# In Support of OMA and TDECQ min comments: r03-5, r03-6, r03-8, r03-7

# In Support of OMA and TDECQ min comments

# TDECQ Measurements

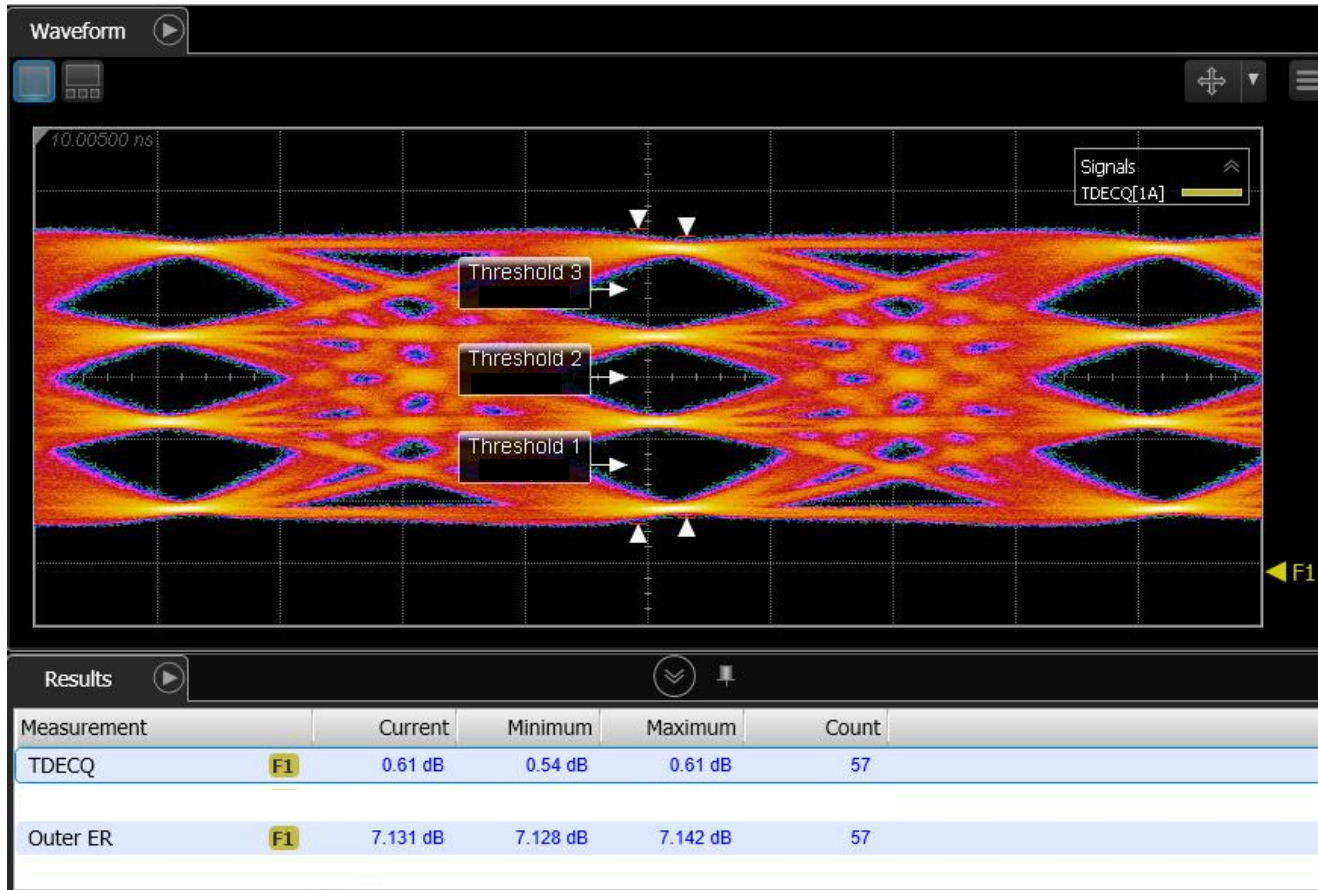
Equalized, Ref 3dB B/W: 12.89 GHz

Tap Values:

0.005067, -0.062306, 1.044927, 0.010887, -0.000367

- TDECQ values  $\leq 0.9$  dB possible with high bandwidth transmitters
  - Above measurements show 0.6 dB with current TDECQ methodology
  - Worst case dispersion would add additional penalty, expected less than 0.3 dB
